RIVER ROAD PARK SUBDIVISION

APPLICATION NUMBER 7 DATE August 18, 2011

REQUEST Subdivision

DETAIL SITE PLAN

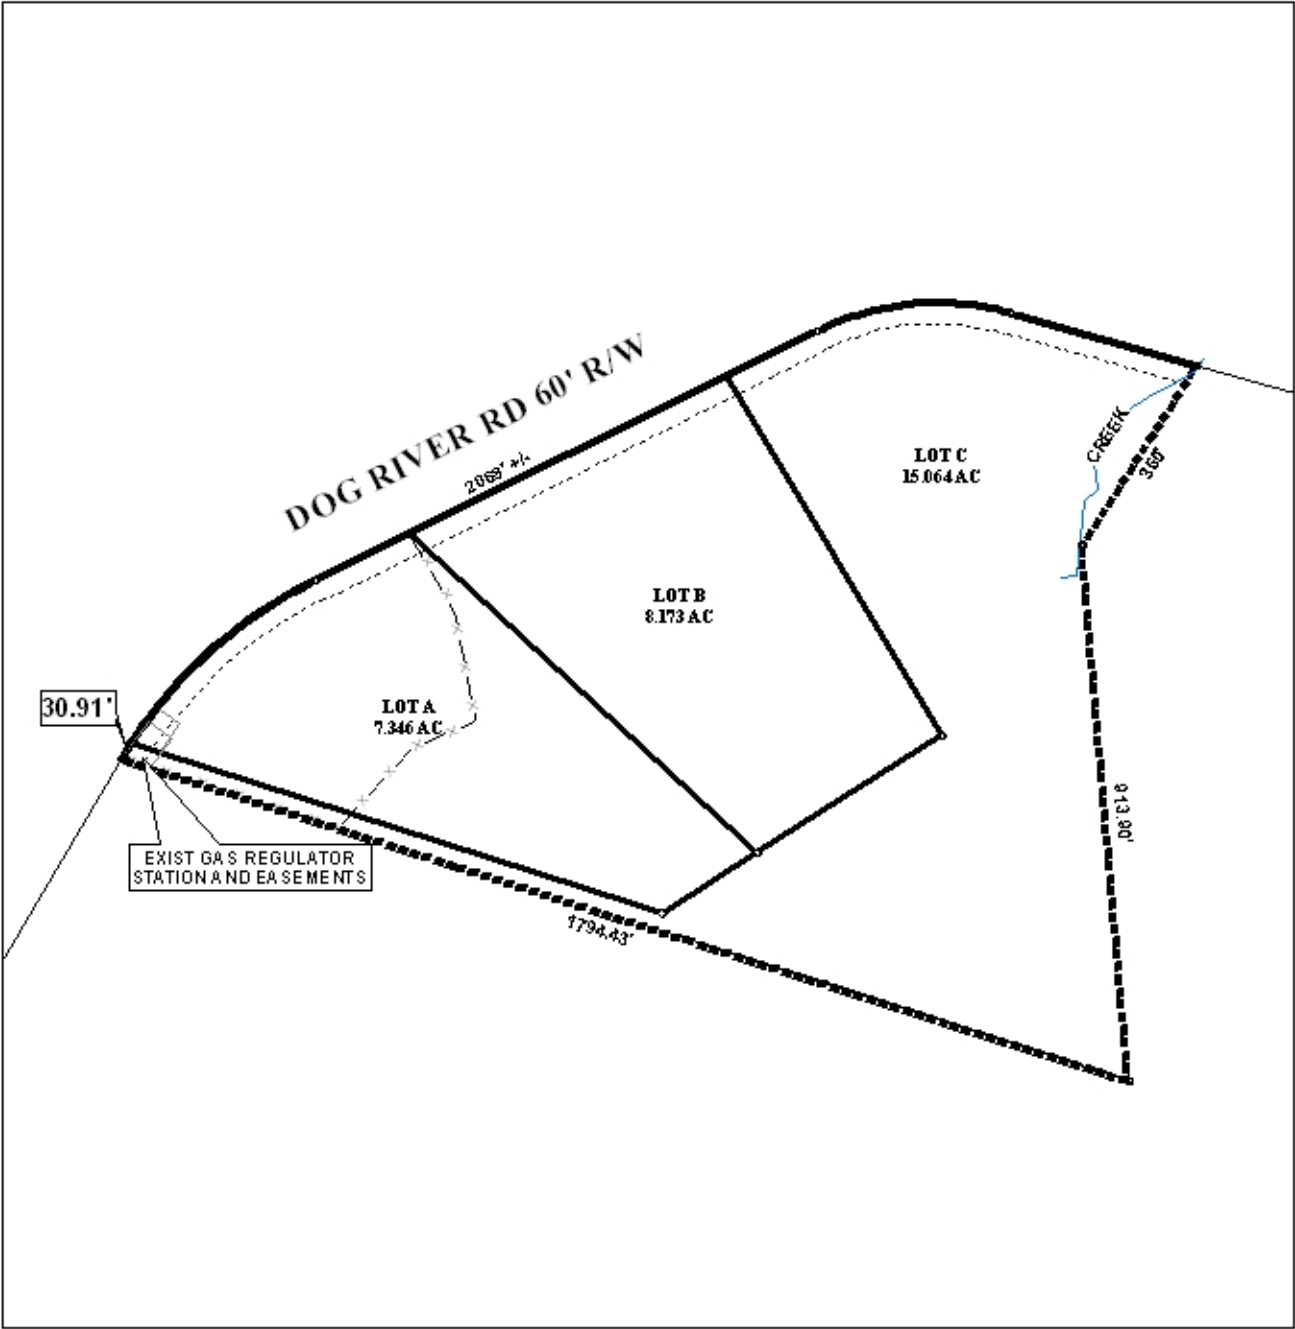
Each lot meets the minimum requirements of the Subdivision Regulations. However, the plat should be revised to label each lot with its size in acres, or a table should be furnished on the Final Plat providing the same information. As on the preliminary plat, the 35' minimum building setback line should also be illustrated along Dog River Road for all lots on the Final Plat. The plat should be revised to also show a 25' minimum building setback line on Lot C as measured from the rear lot line of Lot A. As proposed, Lot C is partially a flag lot of irregular shape and does not meet the requirements of Section V.D.1. and V.D.3. of the Subdivision Regulations; however, the configuration has been such since the 1994 parceling of Lot 4, Riverview Pointe Subdivision, and other approved flag lots and irregularly-shaped lots are within the area. Therefore, a waiver of Sections V.D.1. and V.D.3. would be justified for Lot C. A note should be required on the Final Plat stating that future subdivision of Lot C would require additional road frontage via construction of a road or roads into Lot C.

Dog River Road is a minor street without curb and gutter, but with a compliant 60' right-of-way for such; therefore, no dedication would be required. Since each lot would have over 200 linear feet of street frontage, as a means of access management, a note should be required on the Final Plat stating that each lot is limited to two curb cuts to Dog River Road, with a curb cut on the "flagpole" of Lot C counting as one of its allowed curb cuts, with the location, size and design of all curb cuts to be approved by County Engineering and conform to AASHTO standards.

- 1) revision of the plat to label each lot with its size in acres, or the furnishing of a table on the Final Plat providing the same information;
- 2) illustration of the 35' minimum building setback line along Dog River Road for all lots;
- 3) revision of the plat to also illustrate a 25' minimum building setback line on Lot C as measured from the rear lot line for Lot A;
- 4) placement of a note on the Final Plat stating that any future subdivision of Lot C will require additional road frontage via construction of a road or roads into Lot C;
- 5) placement of a note on the Final Plat stating that each lot is limited to two curb cuts to Dog River Road, with a curb cut on the "flagpole" of Lot C counting as one of its allowed curb cuts, with the location, size and design of all curb cuts to be approved by County Engineering and conform to AASHTO standards;
